St. Bernard Parish Library
Construction Documents Review by Staff
July 13, 2020

After reviewing the construction documents, and assuming that this library will be used for many years, and that running additional wires during the construction phase is a LOT cheaper than putting them in after the building is complete, the staff, especially Dwight, has made the following professional observations:

TV & DISPLAYS

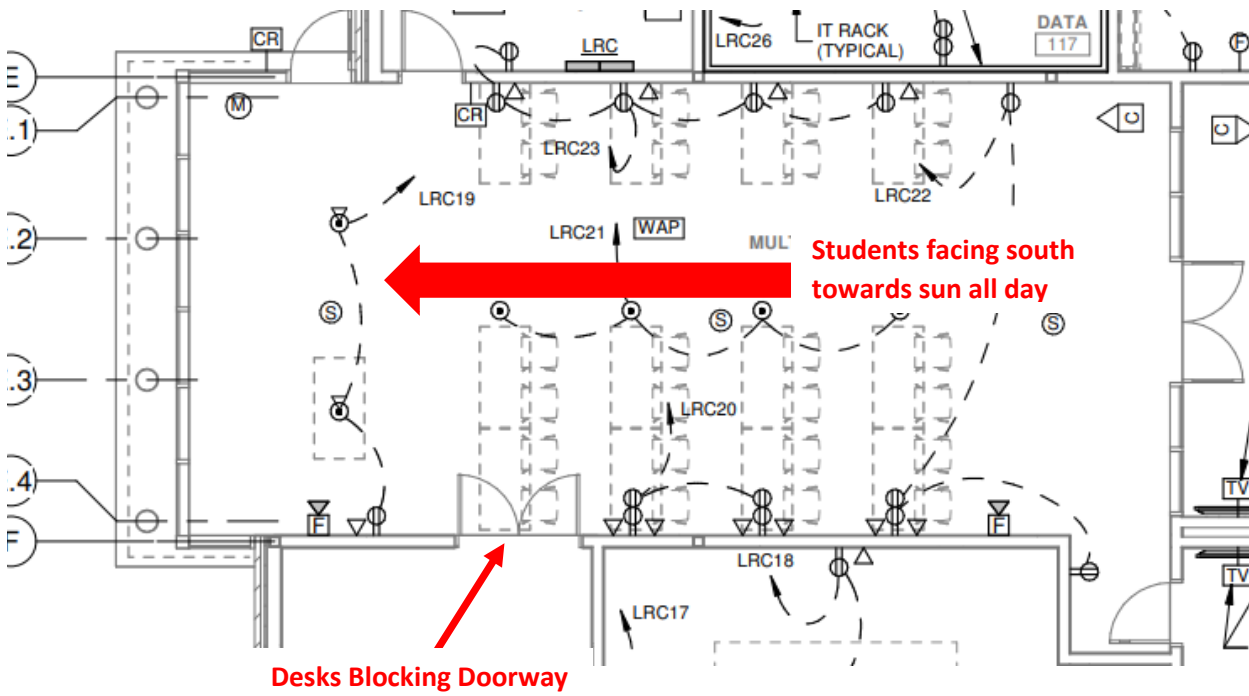
2. **TVs and video.** The TV monitor facing the patrons as they leave the library is poorly placed. Patrons who have finished checking out materials have little inclination to sit and watch announcements when they are ready to leave. This TV has been moved to the area above the book drop return slots, visible upon entry. Additional jacks (for future TVs) have been placed in the multi-purpose and computer training rooms. An existing TV in the staff area used to monitor security cameras was not in the document and has been added. The main meeting room would be better served with one larger TV in the center instead of two smaller TVs on each side. All TV jacks need one coax connector and two Ethernet connectors, due to the internal PC requiring one and the TV requiring one for on/off/volume control. **OK.**

- 1 Entrance Hall
- 1 Teen Area
- 1 Outside computer lab
- 1 Staff Area (security)
- 1 Over book return slots
- 1 Children's Area

- All display TVs need:
- 1 RG-6 Coax outlet
 - 2 Ethernet Cat 6
 - 1 Duplex power outlet

New Multi-Purpose Plan

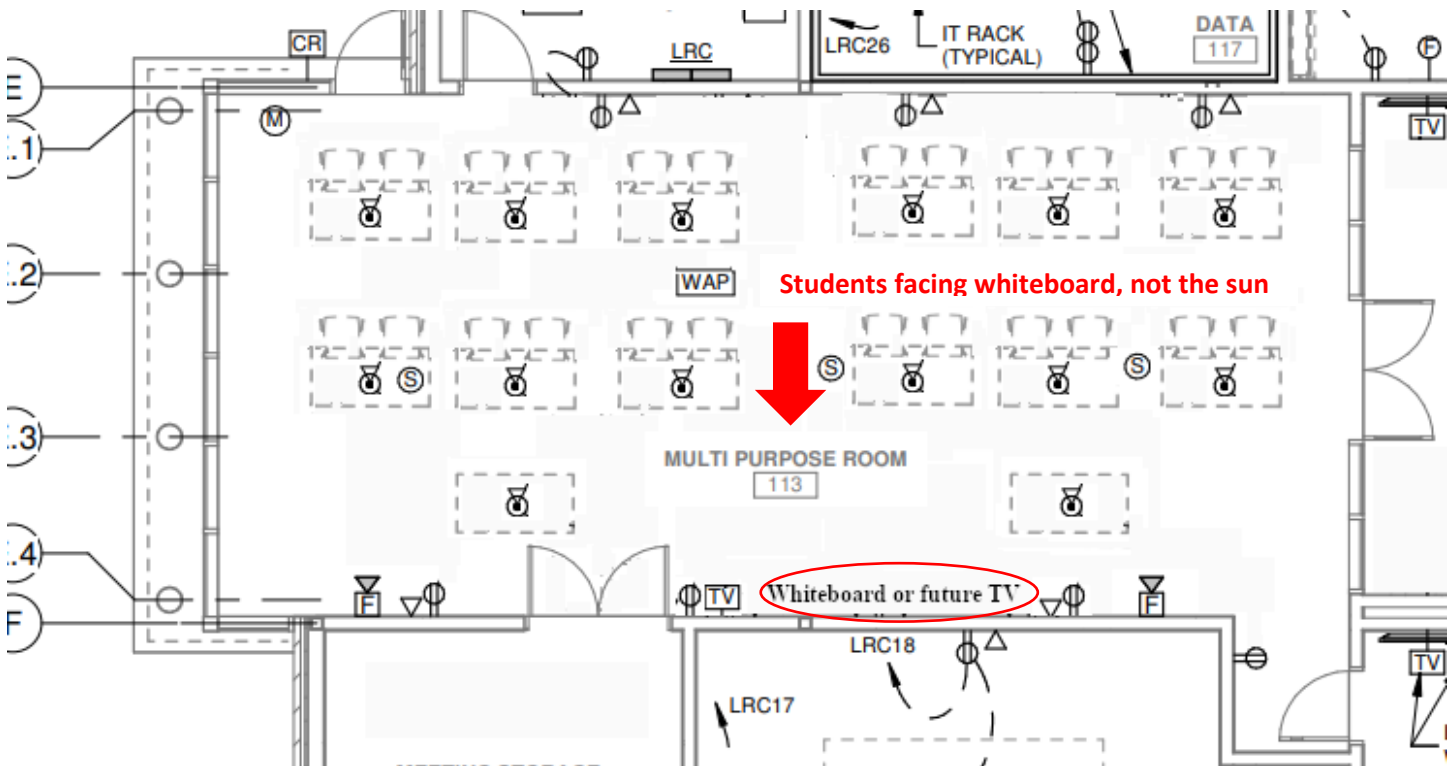
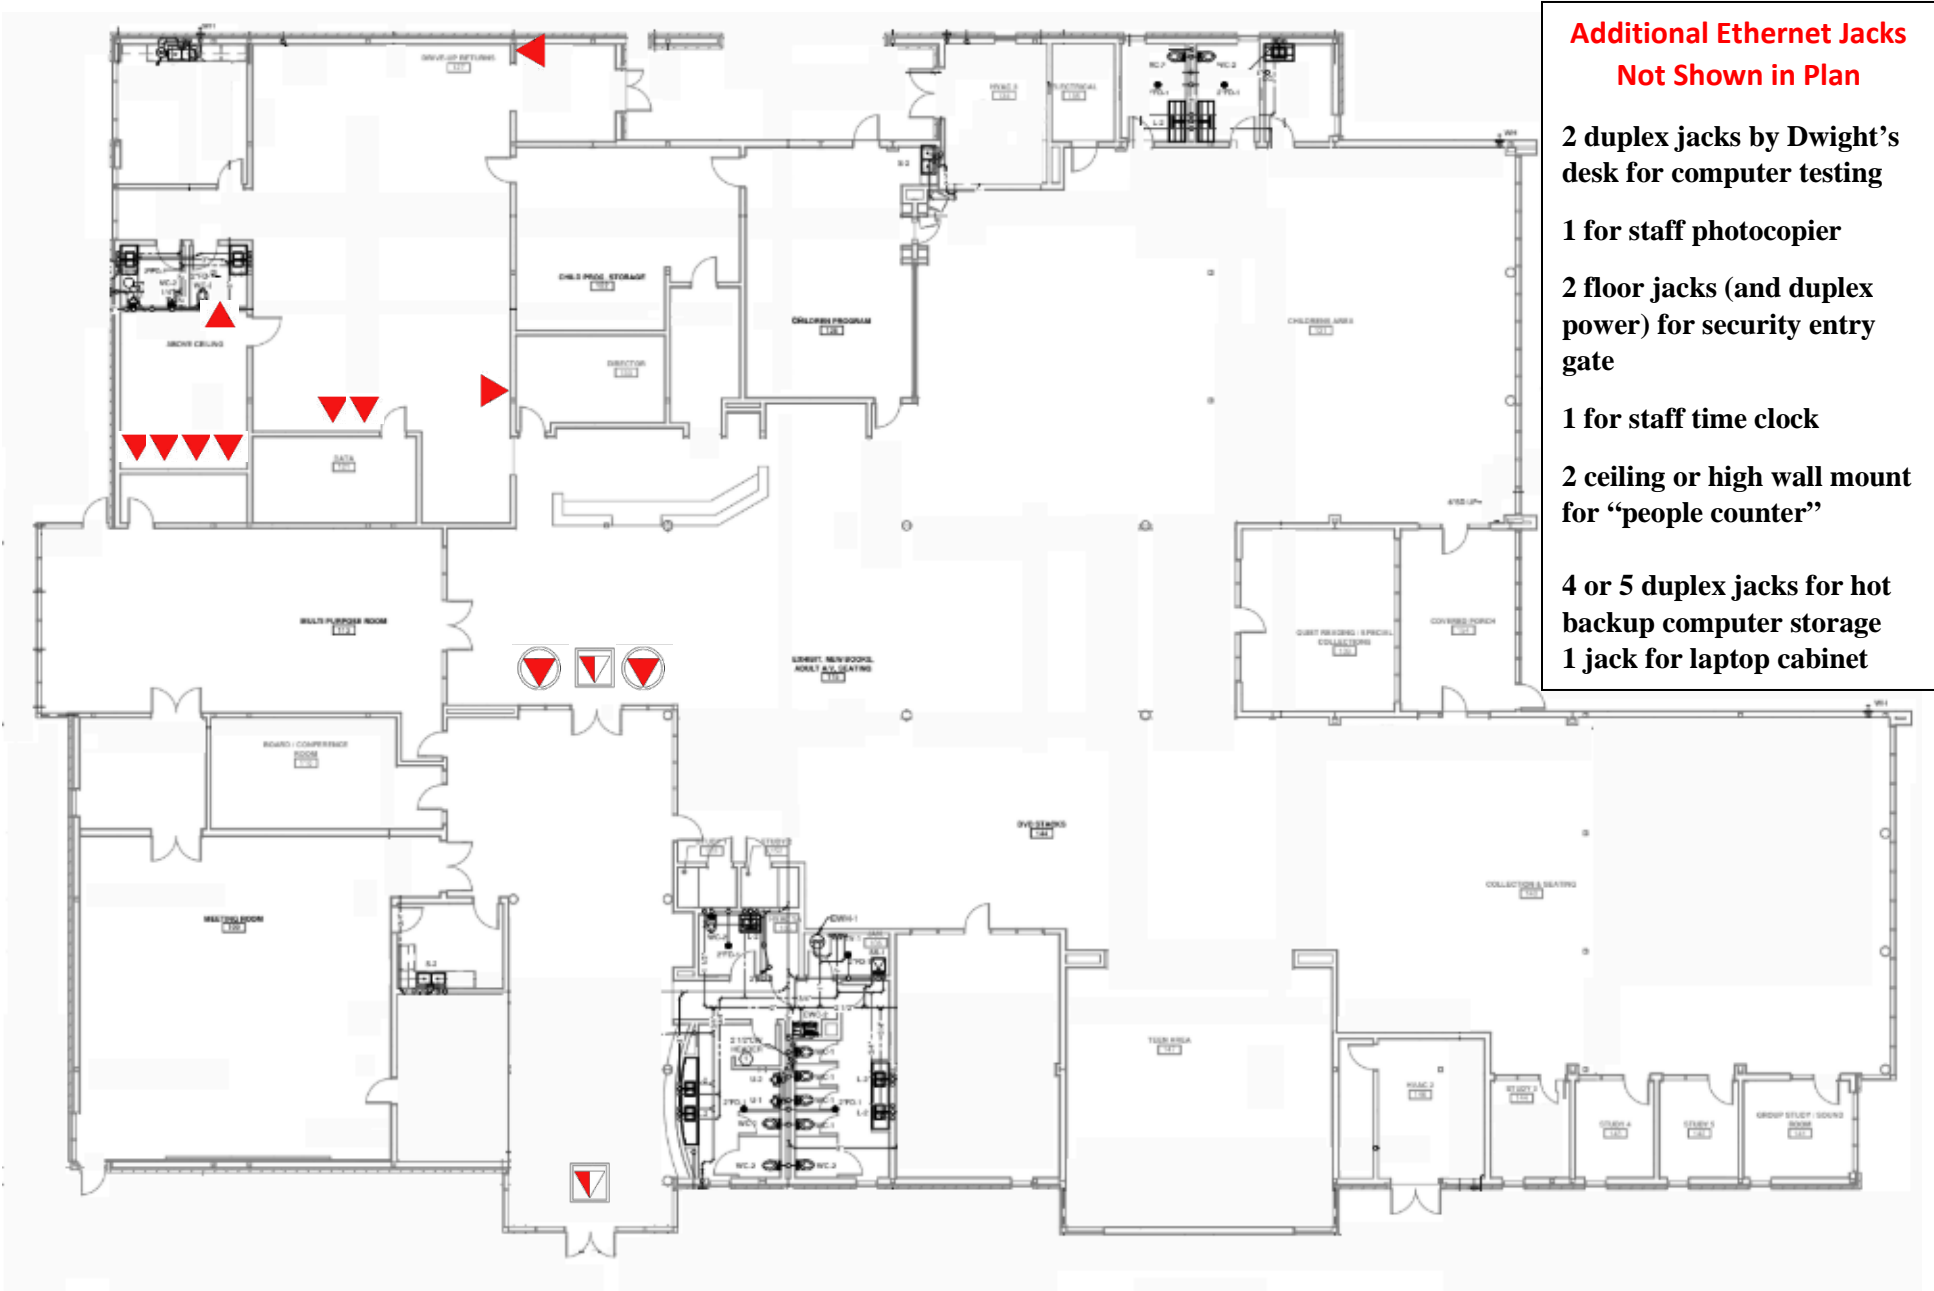
3. **Multi-Purpose room.** The existing plan has all the student's desks looking at the huge southern window, facing the sun, which makes it hard to see the instructor. Also, this plan blocks the double doors to the storage room. A better plan would have the desks face one of the walls, allowing either a whiteboard or TV to be mounted. This requires floor power and data receptacles for each desk. **OK.**

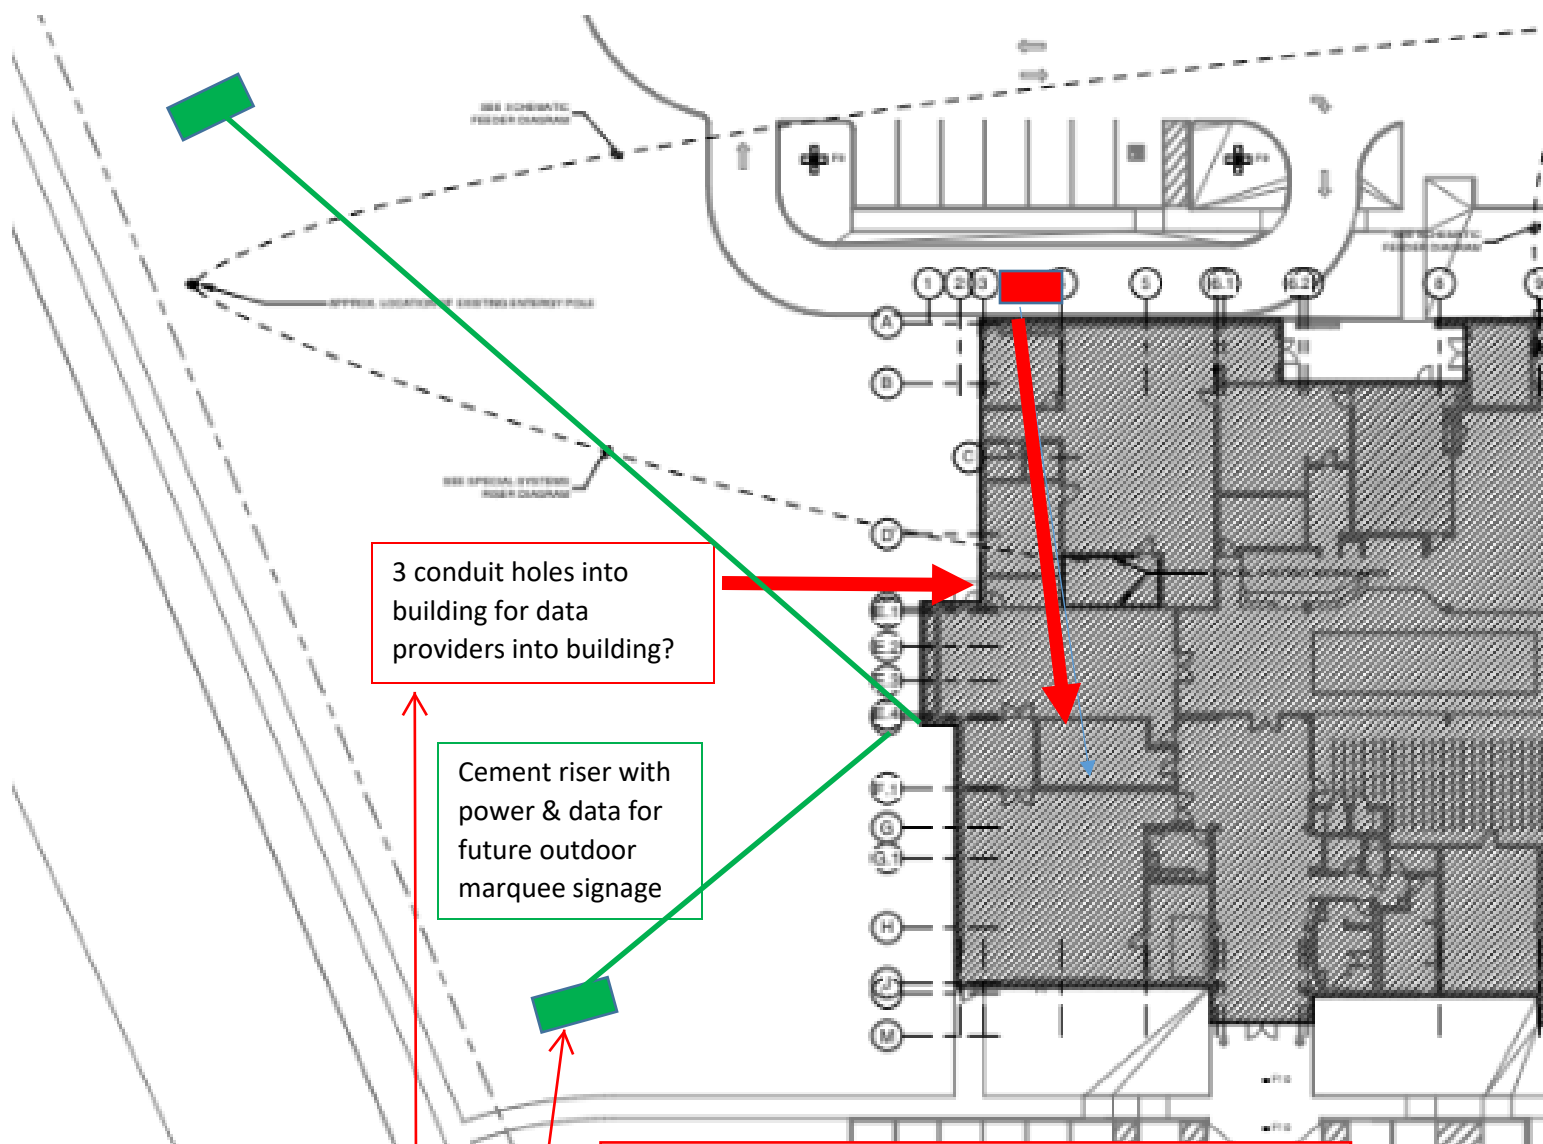
4. **Additional Ethernet computer jacks.** Jacks for the "hot backup" PCs and the laptop cart in the closet were not identified in the drawings. Dwight requires at least six Ethernet jacks on the testing bench area for multiple PCs, as well as access to all the different LANs in the library. In addition, we need jacks and power in the floor for a door security gateway using RFID tags, as well as two ceiling jacks for a computerized people counting system, as well as at least one jack near the staff entryway for a time clock check in/out system. Also, there was no jack shown for the staff photocopier. **OK.**

- Additional Ethernet Jacks
Not Shown in Plan**
- 2 duplex jacks by Dwight's desk for computer testing
 - 1 for staff photocopier
 - 2 floor jacks (and duplex power) for security entry gate
 - 1 for staff time clock
 - 2 ceiling or high wall mount for "people counter"
 - 4 or 5 duplex jacks for hot backup computer storage
 - 1 jack for laptop cabinet

- ▼ Duplex computer jacks mounted 2 feet above floor
- ▼ Floor mount ethernet and power for security gates
- ▣ Ceiling mount jack for people counter (2 locations)

Outside Non-Camera Concerns

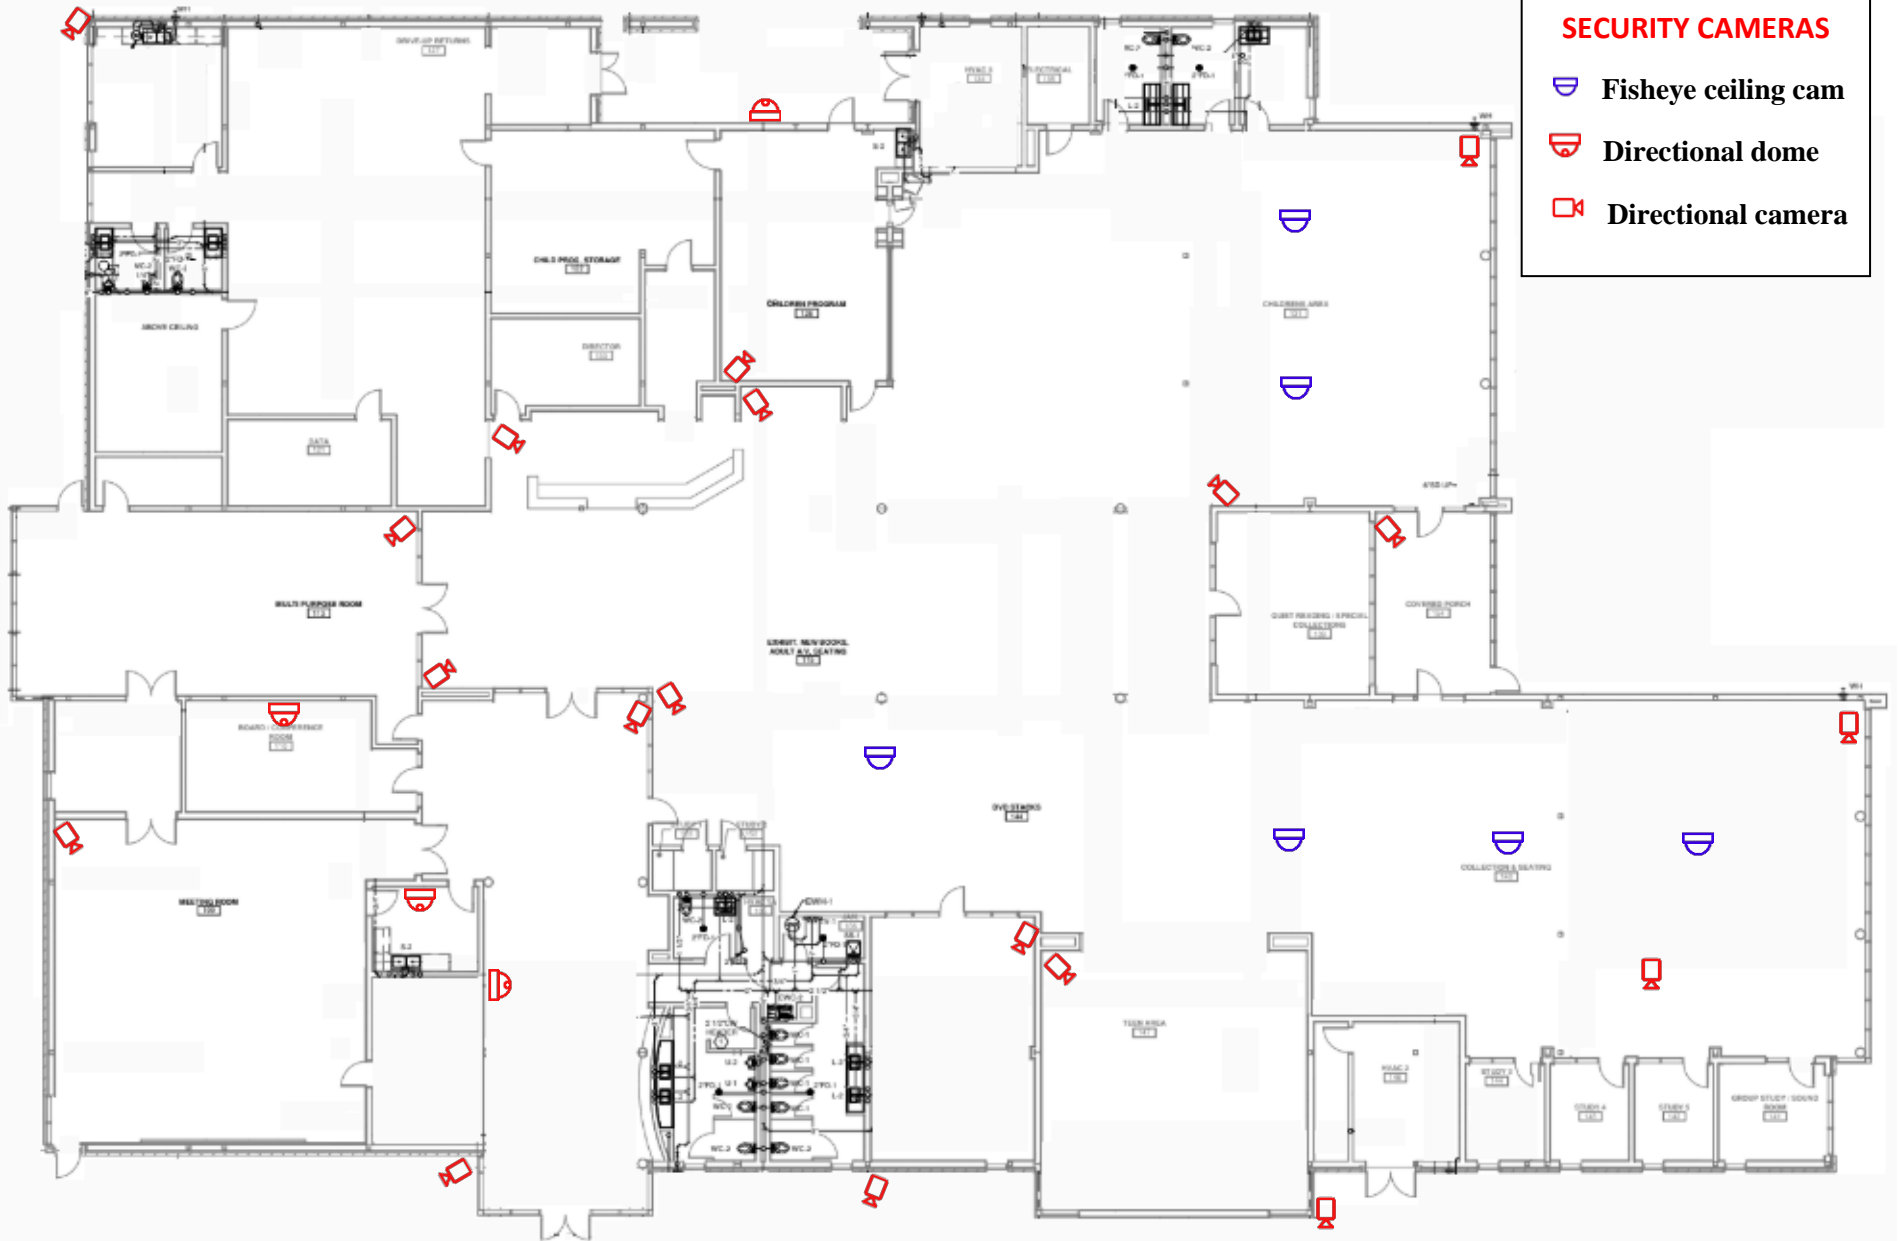
5. **Outside wiring.** The plans do not address the location where the data and voice conduits from Cox and AT&T or an optional third vendor will be located. Each vendor will need its own entry conduit. In addition, the southwestern corner needs to have a terminus (covered outlet box) to house coax wires for a possible addition of a TV antenna and/or a small satellite dish or microwave link for video and data. Cement riser slabs should be installed a proper distance away from Judge Perez drive (to allow for a lane expansion) with power and data so that outdoor marquee signs can be installed.

3 conduit holes into building for data providers into building?

Cement riser with power & data for future outdoor marquee signage

Are these to route back to the IT Room? AV Room? Capped at future outdoor location with pull wire?

Sheet E100 calls for the location of the vendor conduits to the Entergy pole. Sheet E301 indicates what these conduits are for. Please advise the quantity and size of the conduits for Cox and if these should also be brought to the Entergy pole.

These conduits will be routed underground from Entergy pole to IT Room, unless noted otherwise.
